Application Note

DXPC Diagnostic LEDs

AN55

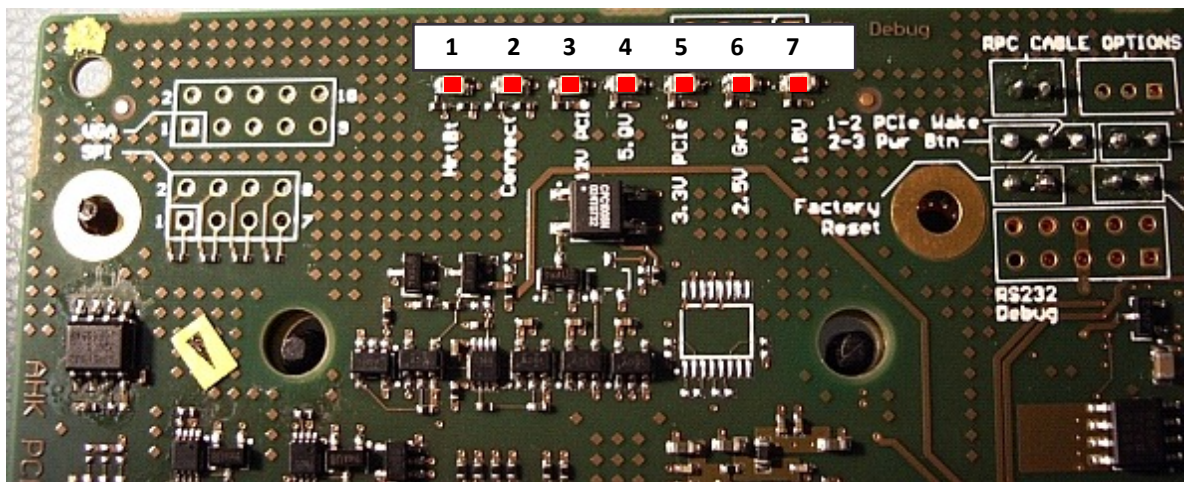
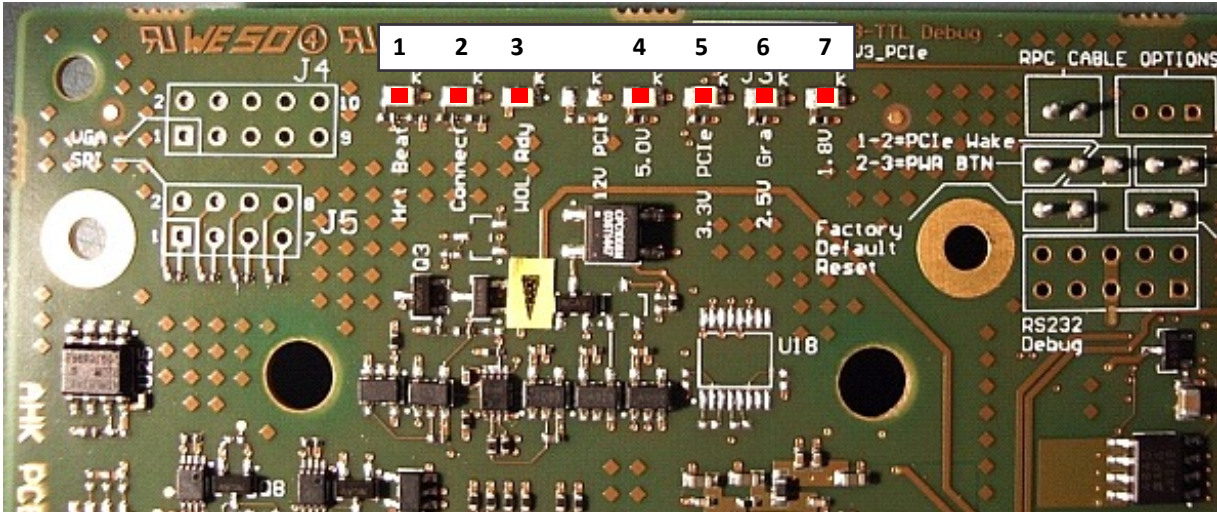
When compared to earlier versions, revision 5 of the DXPC has some differences in these LEDs; The 12V PCIe LED is omitted and a “WOL Rdy” LED has been included. This document will explain the function of the LEDs, contrasting Rev4 (and below) with Rev 5.

3 – WOL Rdy

This LED, like others, only illuminates when the host machine is fully powered up and is intended for in-house and in-field diagnostics only. The function of WOL Rdy is to flag that the Realtek network chip has properly read the MAC address of the card from a memory device which it shares with the Teradici. Thus, if this LED is illuminated and the host is correctly configured to wake from a PCIe Wake On LAN event (which may need BIOS setup changes and is not supported for every host machine), a Magic Packet sent to the DXPC’s MAC from a Zero Client (or suitable software etc), should wake the host machine (having AC line power) into full power operation.

A note on the omission of the 12V PCIe LED from the initial release of Rev 5.

The omission of the 12V PCIe LED from the Rev 5 DXPC occurred for three reasons. Firstly, to reduce the operating power consumption of the DXPC. Secondly, to reduce the total Bill of Materials and placement costs and thirdly due to the 5.0V LED illuminating implying that 12V is present on the card.
